**PLANNING COMMISSION
STAFF REPORT**

July 17, 2025

AGENDA ITEM: Planning File No. **MAJ-25-0004**, a Major Site Plan application for a proposed multi-unit residential development and **CU-25-0001**, a Conditional Use application to allow multi-unit residential uses in the Gateway (GW) Zone District.

LOCATION: 92 Beaver Lodge Rd Bldg A, 86 Beaver Lodge Rd, Bldg B, and 80 Beaver Lodge Rd, Bldg C / Lot 5 RainTree Two Sub, Lot 6 RainTree Two Sub and Lot 7 RainTree Two Sub

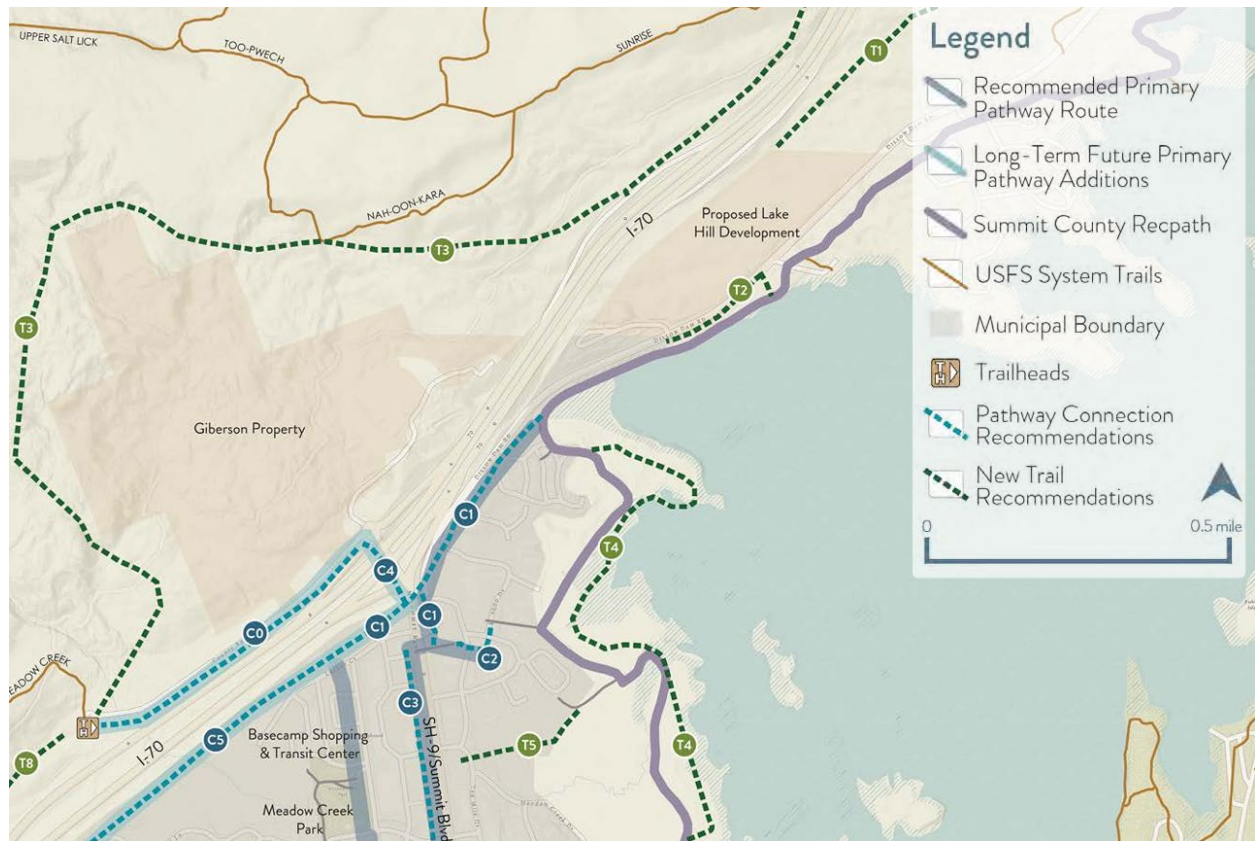
The application appears to meet these standards at this time. The access will be further reviewed for compliance with these standards at the final stage of the Major Site Plan review, where the Frisco Public Works Director will review it.

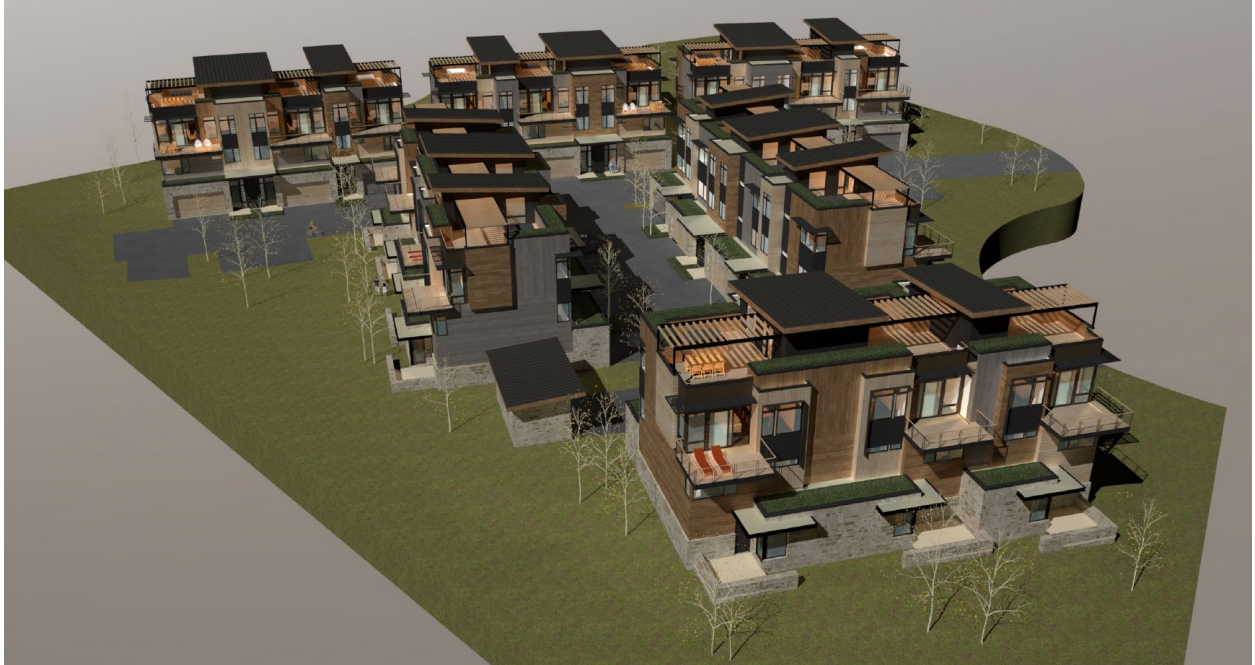
- a. *Deep eaves or overhangs, at least 24 inches in depth;*
 - The roof and balcony overhangs appear to extend significantly beyond wall planes, particularly at roof decks and patio areas, satisfying the 24" depth requirement.

- b. *Balconies, porches, or patios;*
 - Numerous roof decks and ground-level patios are visible for most units, especially for Buildings D, E, and F, which include private terraces.

- c. *Building elements that provide shelter from natural elements;*
 - Covered entries and roof overhangs above decks and terraces serve this function, enhancing protection from snow and rain.

- d. *Offsets, insets, bays, or other similar architectural features to add a variety of depths to the wall plane;*
 - The building elevations and footprints (shown in the site and floor plans) exhibit clear variations in wall depth through stepped designs and offset planes.

- Although full elevations aren't included, the plans reference "dry stack stone retaining walls" and a variety of facade features, implying different materials/textures across the base, mid-body, and roof lines.

- f. *Variation in roof planes or roof forms, including dormers or gables; or*
 - Multiple roof decks, shed-style slopes, and roof elevations are used. Each building contains distinct roof forms (see roof labels A.1–F.4), indicating variation across the complex.

- Floor plans display various window types and sizes (e.g., vertical narrow windows, standard bedroom windows, and large view-side windows), which meet this requirement.

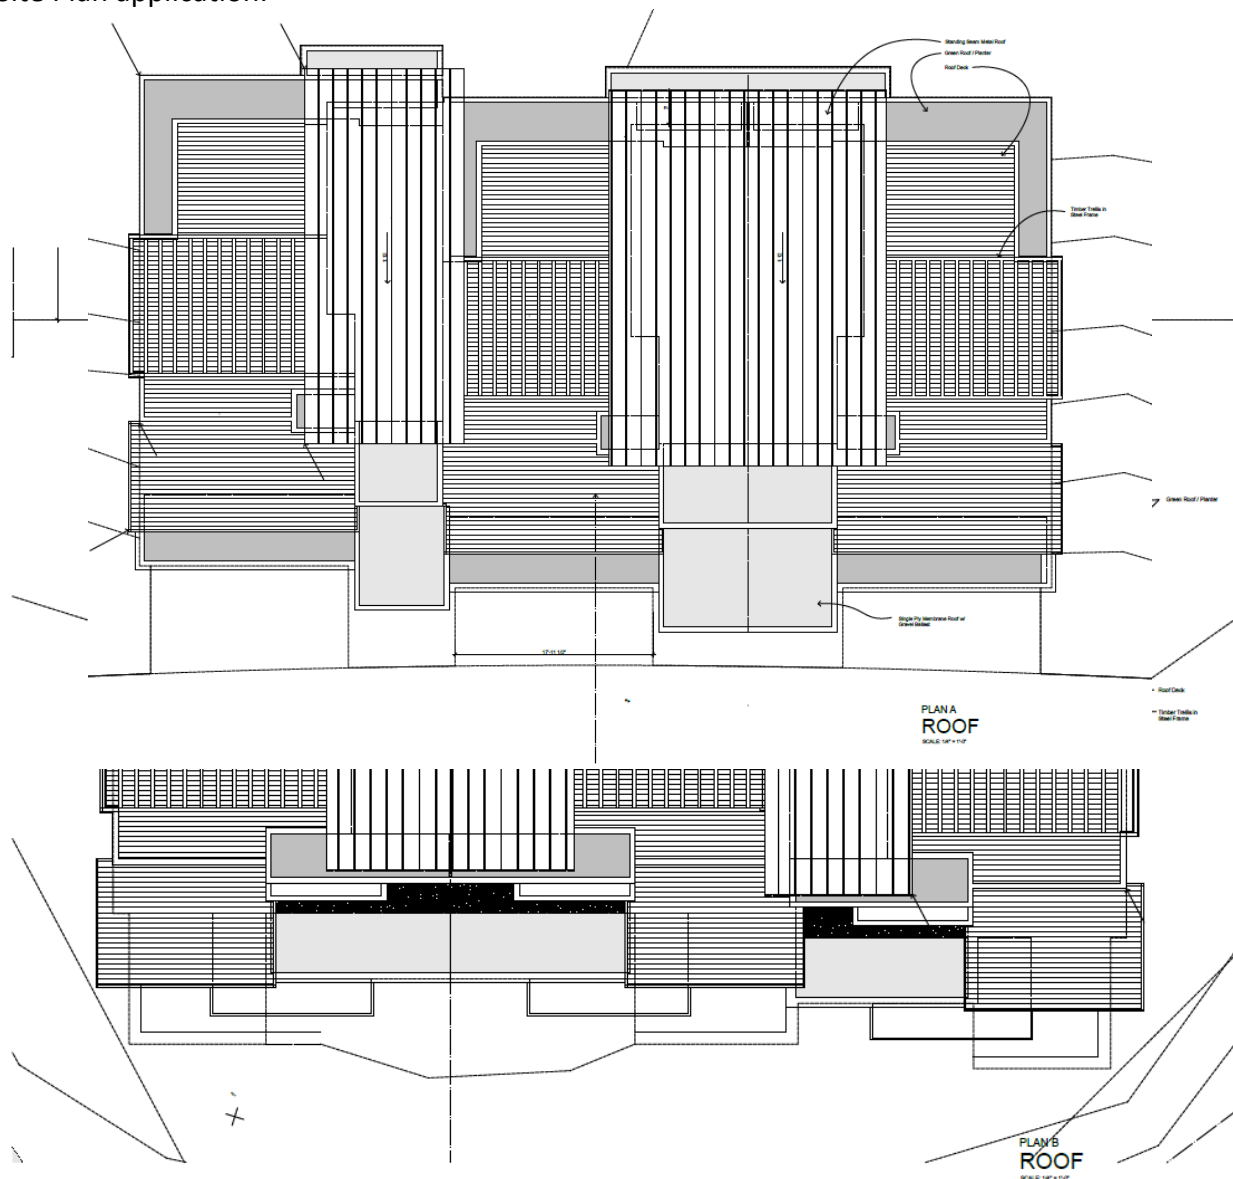
The application with the email from the Applicant on July 10, 2025, notes that the roof plan will be greater than 2:12 for Buildings D, E and F. The roof plan for the final site plan application will be required to show compliance with the roof design standards in the Code. The north and south elevations of the north building have rooflines approximately 160 feet in length, with a single break, so the roof contains a segment that is greater than 66% of the total ridgeline length. The ridgeline also does not change elevation by at least two feet every 27 feet. The east and west elevations of the east building have rooflines of approximately 56 feet in length, with no breaks or changes in elevation. The application will be required to show full compliance with roof pitch and design requirements at time of full site plan review.

The application indicates the roof materials will be a grey color, asphalt shingles and ribbed steel roof panels for the lower sections, which appears to meet this standard. The application will be further reviewed for compliance with the Roof Standards at the time of final review of the Major Site Plan application.
